CITY OF WINTER PARK PLANNING AND ZONING BOARD

Staff Report June 4, 2019

SPR 19-06

REQUEST OF JUSTIN AND LINDSAY VERMUTH FOR APPROVAL TO CONSTRUCT A 1,424 SQUARE FOOT TWO-STORY ADDITION TO THEIR SINGLE-FAMILY HOME LOCATED AT 725 BALMORAL ROAD ON LAKE BERRY, ZONED R-1AAA. VARIANCES ARE REQUESTED FOR THE SOUTHERN SIDE SETBACKS.

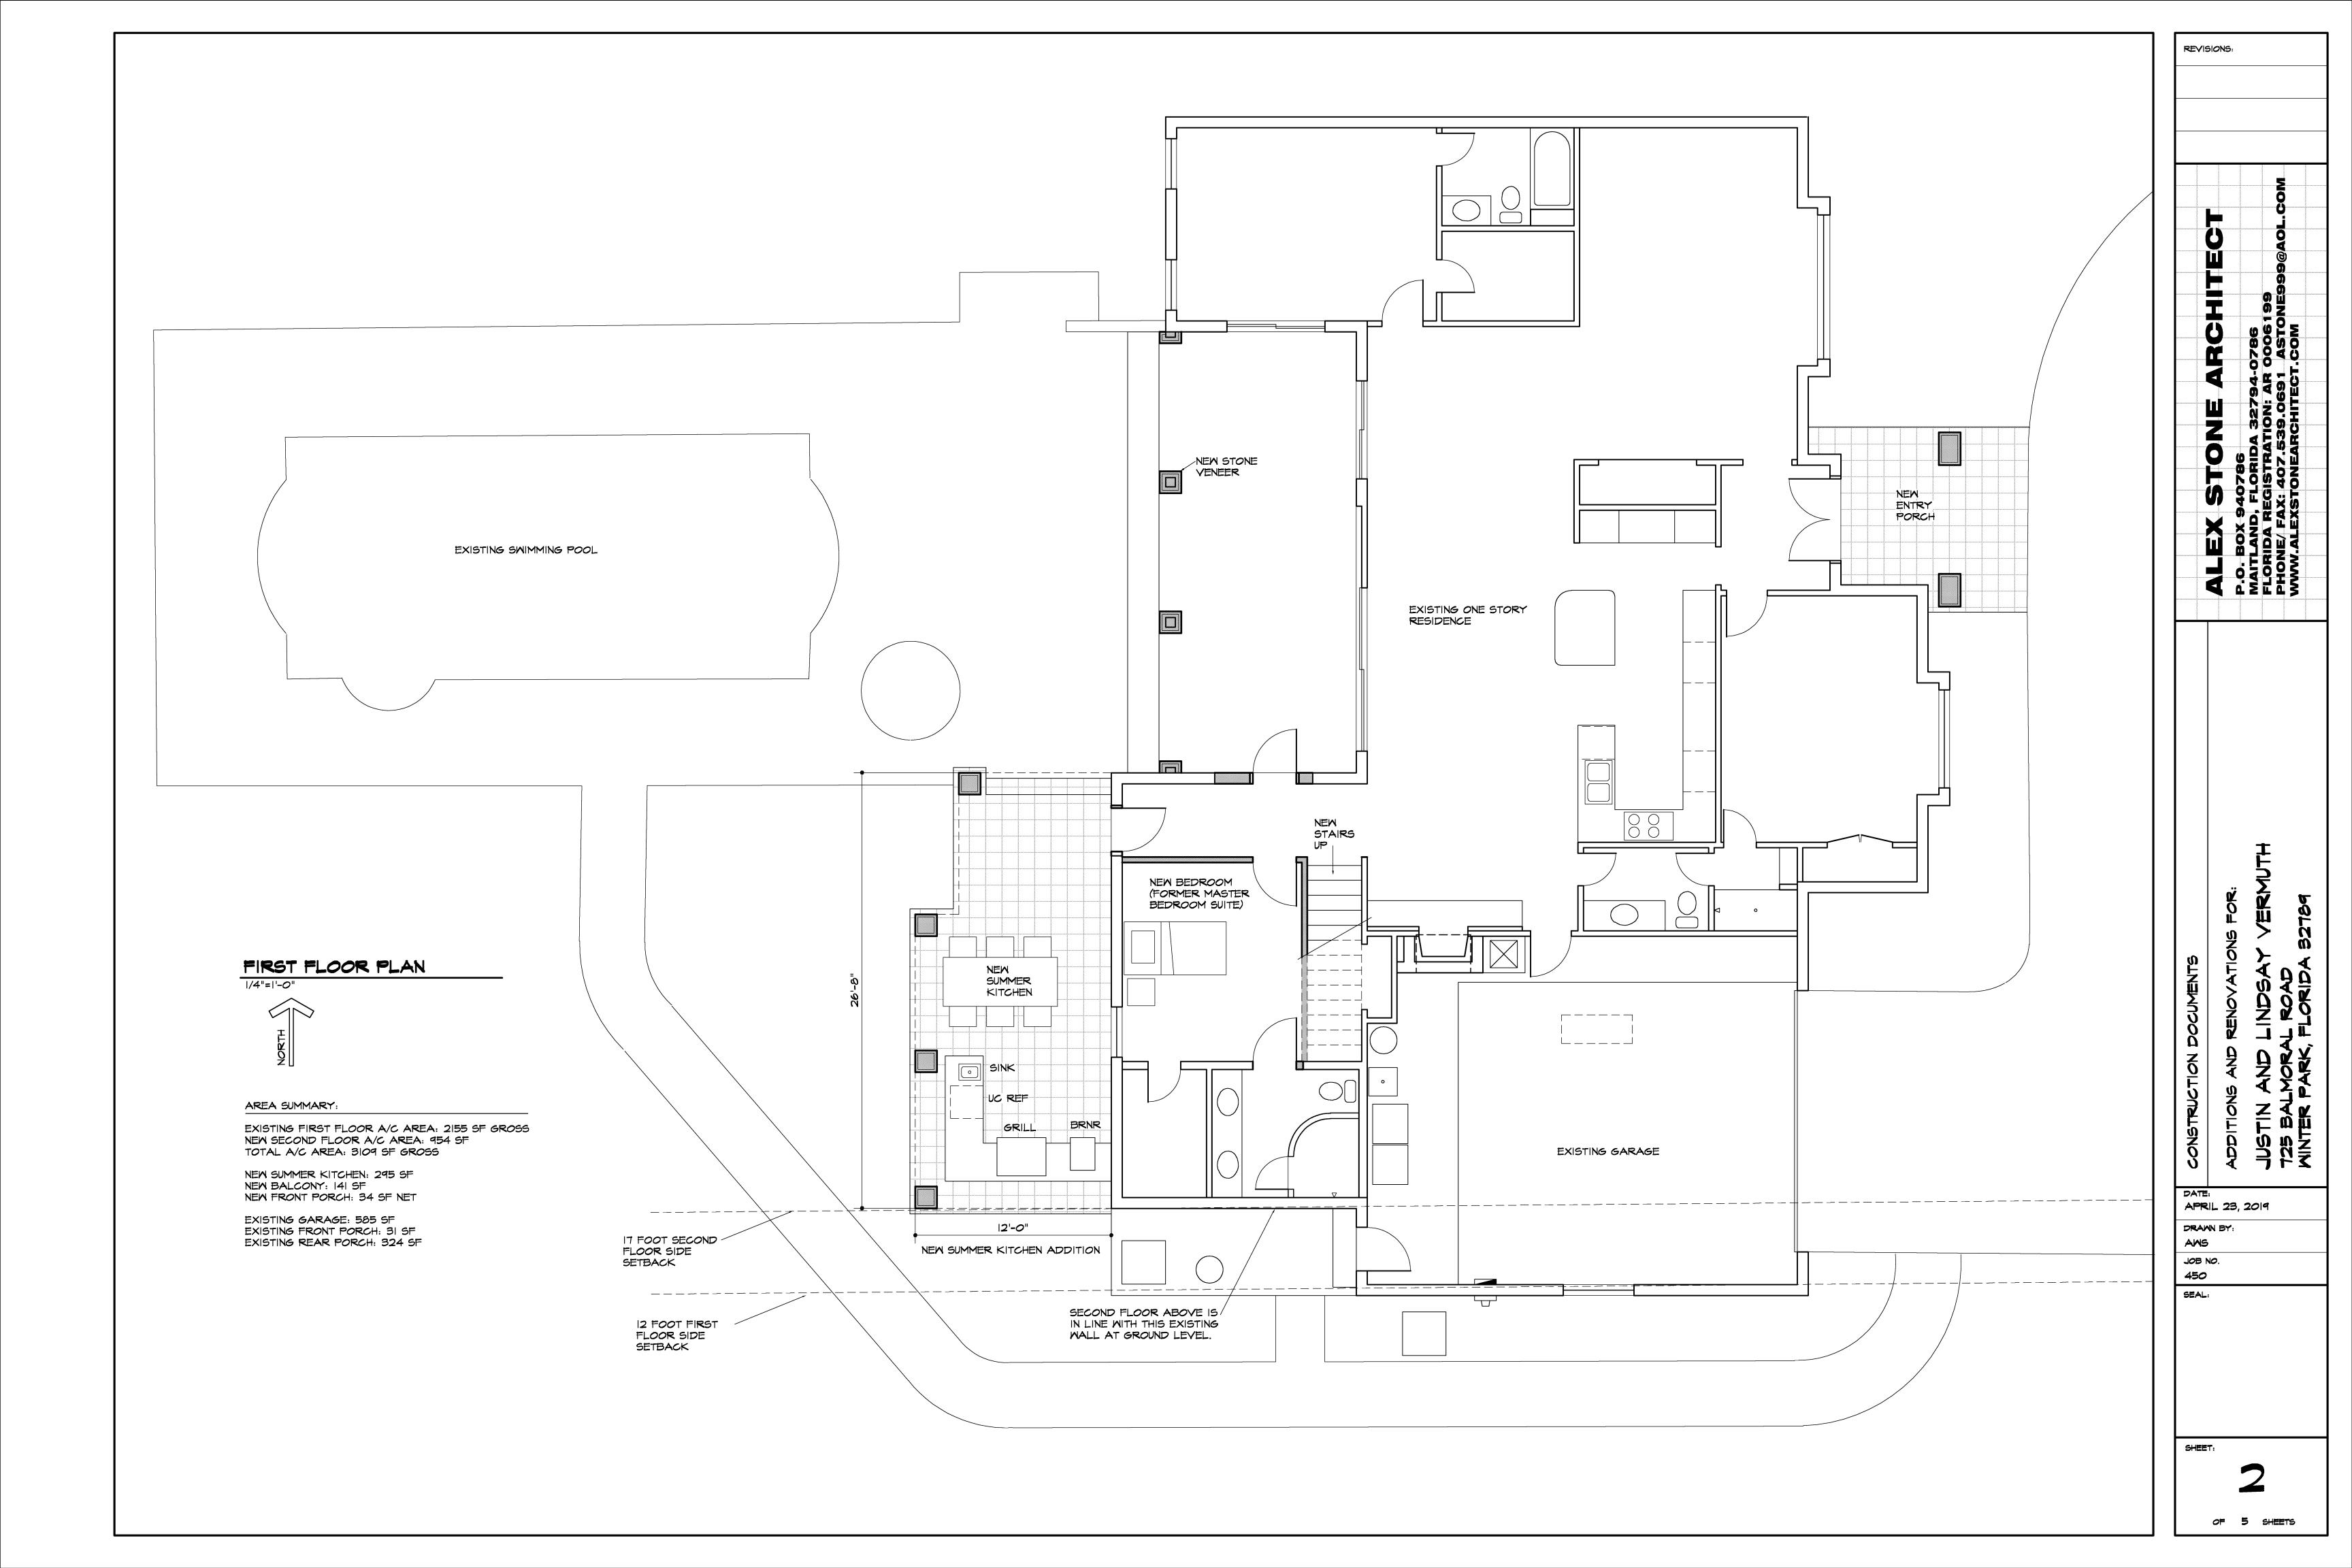
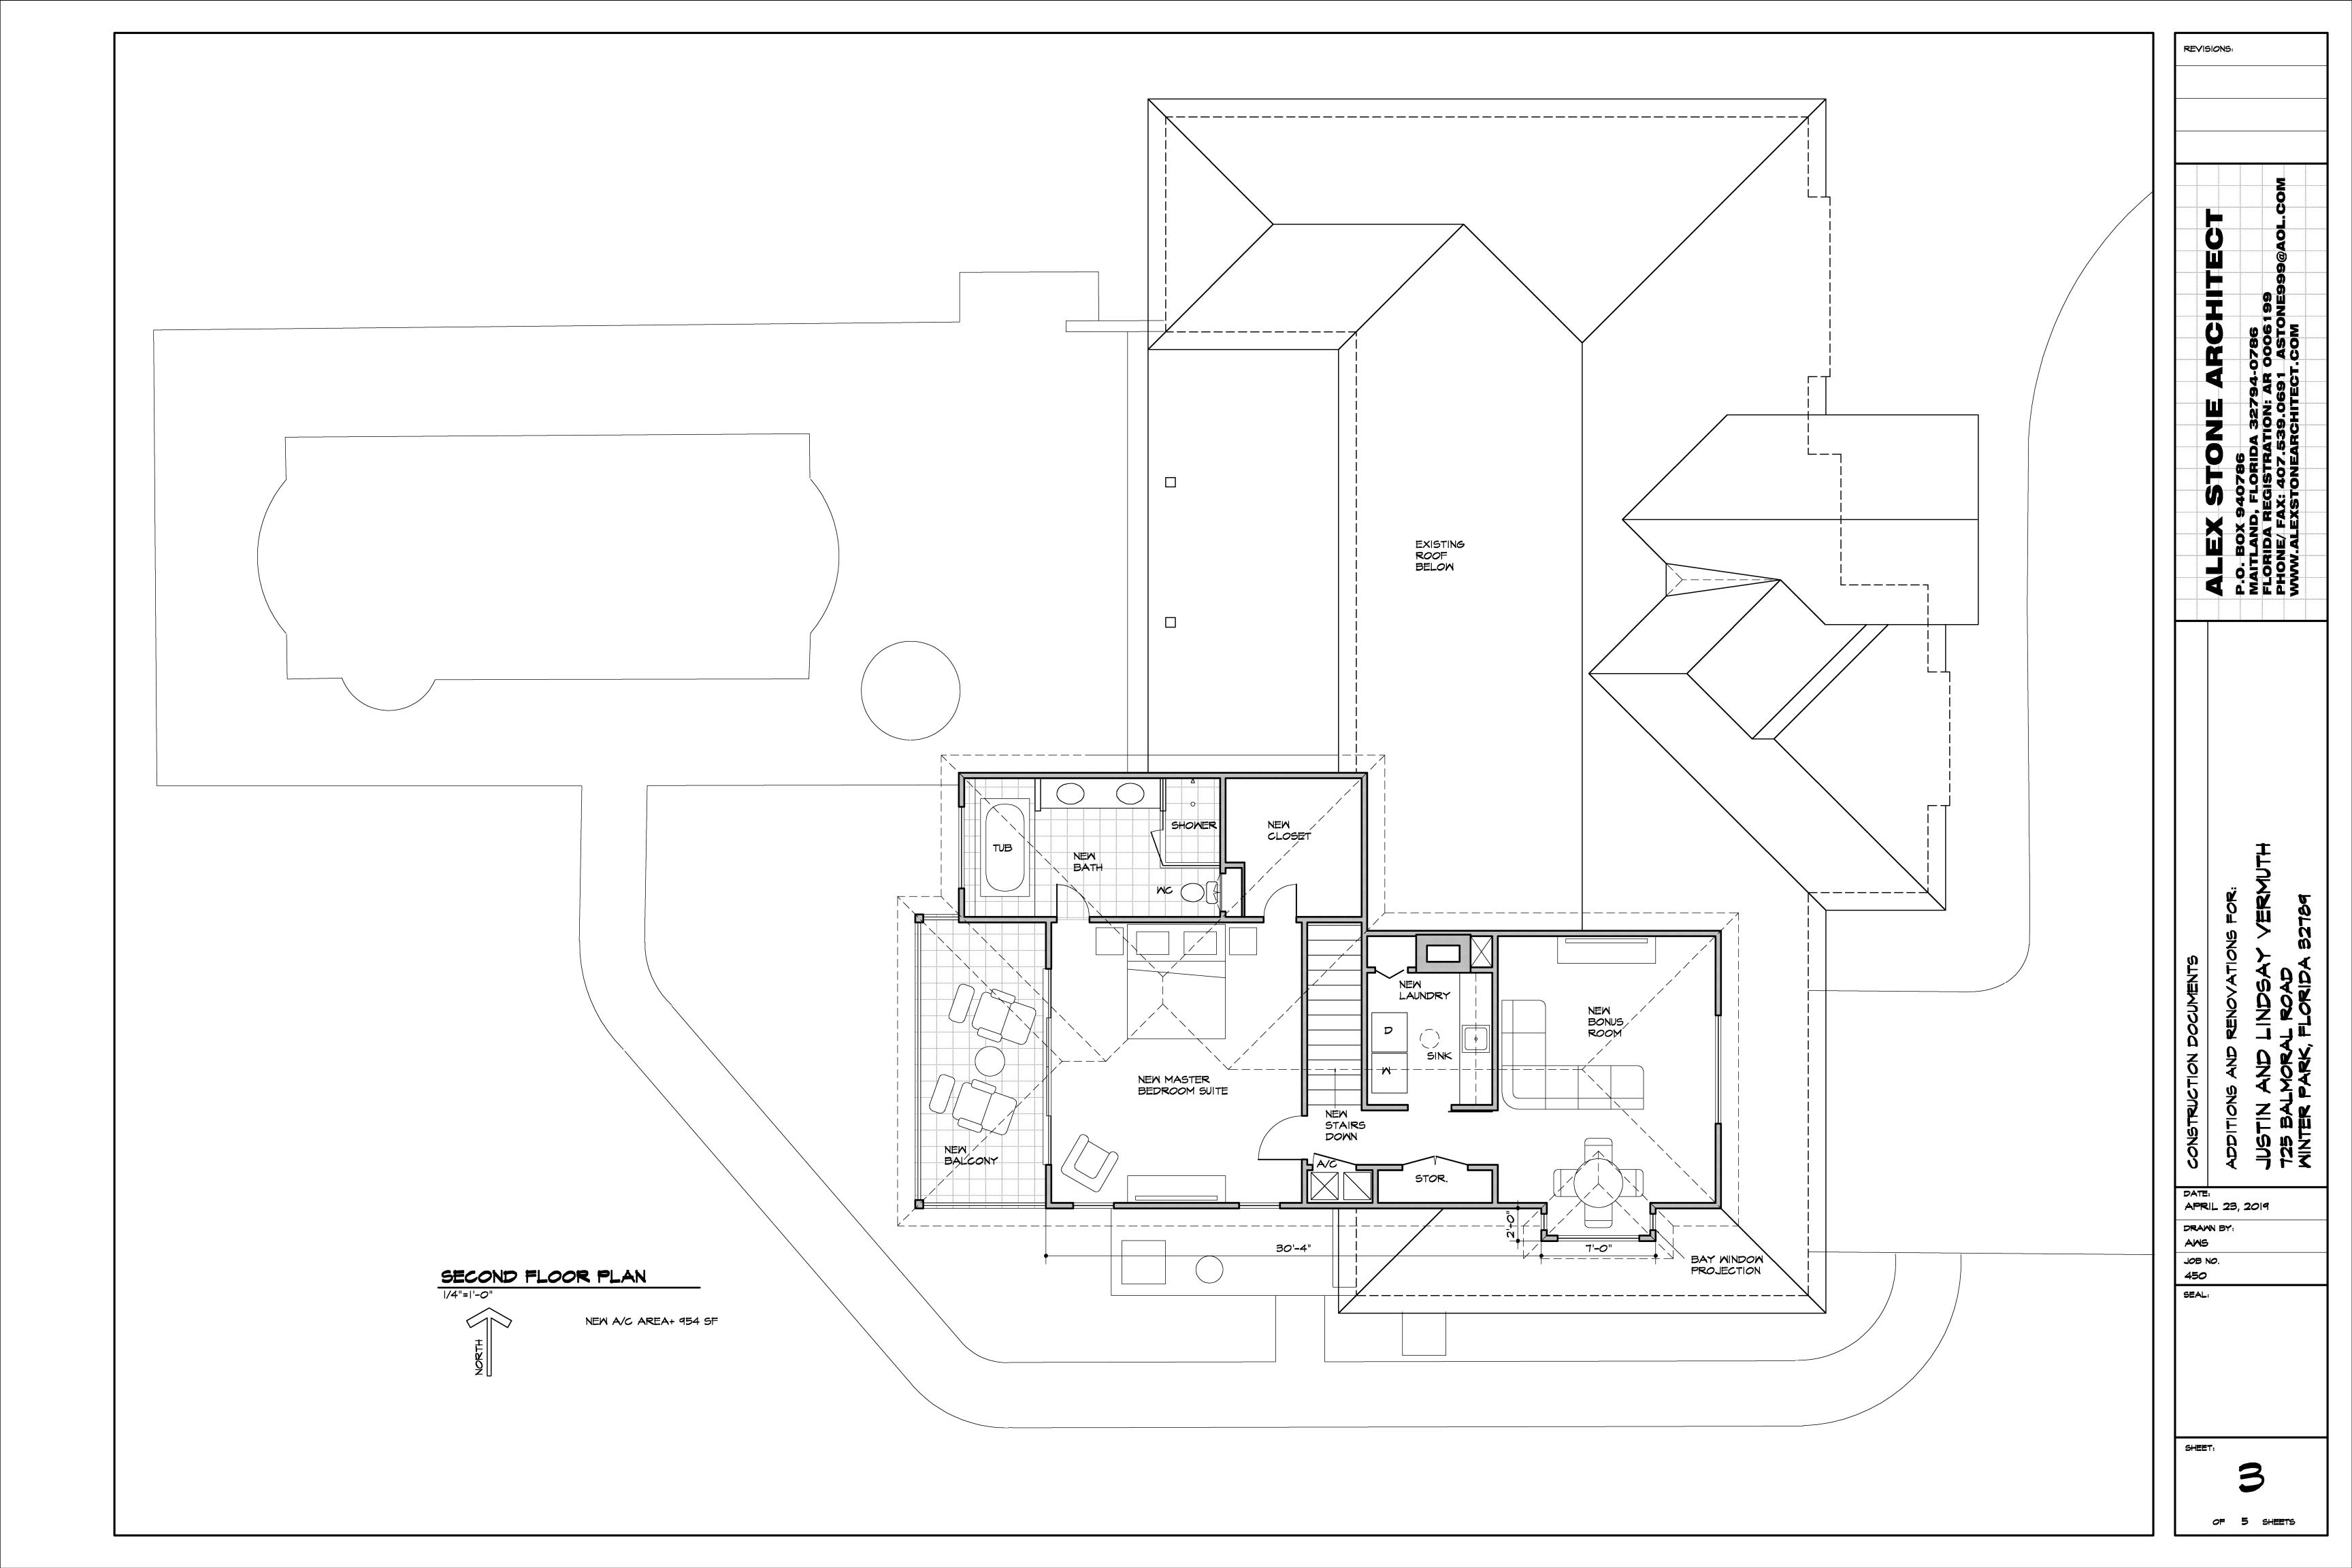
Based on the approximate 96 feet of width of this lot, the required setbacks are 12 feet to the first floor and 17 feet to the second floor. The applicant is requesting a minimal side setback variance to the southern second floor side setback requirements to keep this two-story addition in line with the existing first floor wall on the south side of the home. Due to the slight pie shape to this lot, the applicant is requesting a one inch to three-and-a-half inch setback variance on the south side of the lot. Due to the minimal encroachment into the side setback requirements, and the fact that it does not impact the lake views of the adjacent properties, staff does not see a concern with this request.

creation of a depressed swale area across the waterfront of about one foot in depth. The amount of impervious surface determines the need for the depth of the swale. The applicant is proposing a stormwater swale near the lakefront that is sized to meet the City's code requirements.

LANDSCAPE PLAN

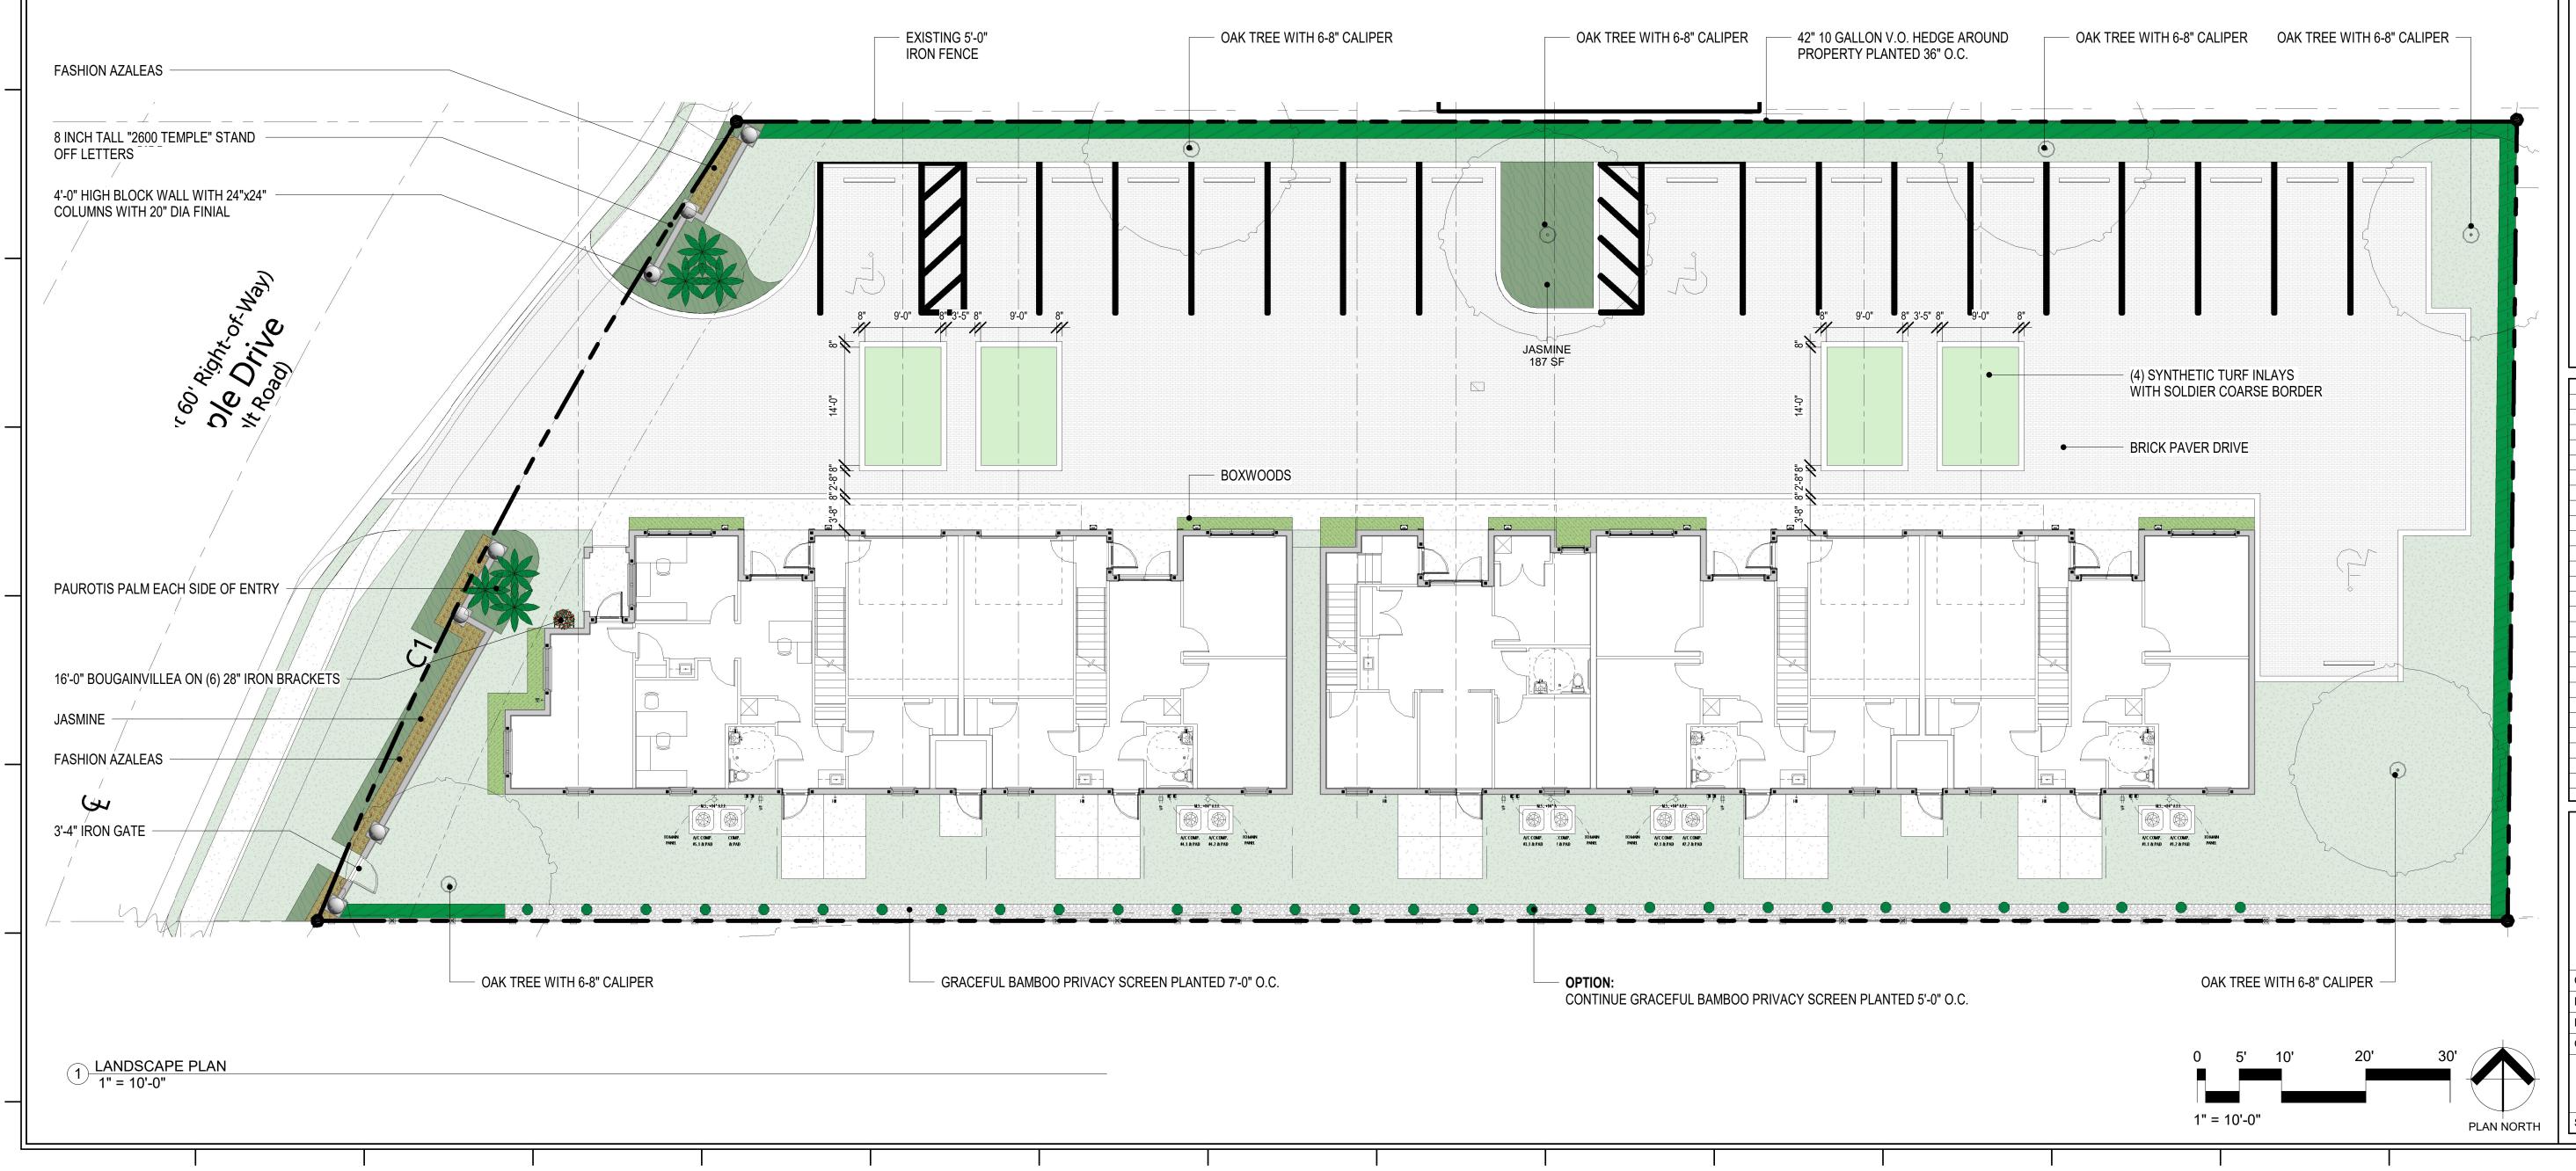
The added sidewalk along the front of the building now provides a pedestrian connection to Temple Drive. The applicant has also shown all four elevations of the building. These updated building elevations have a more residential look and feel and in return are more compatible to the surrounding properties. The southern elevation is the side with the least design enhancement, but the applicant is proposing 25 gallon graceful bamboo trees placed every five to seven feet to screen this side of the building from the adjacent residential properties.
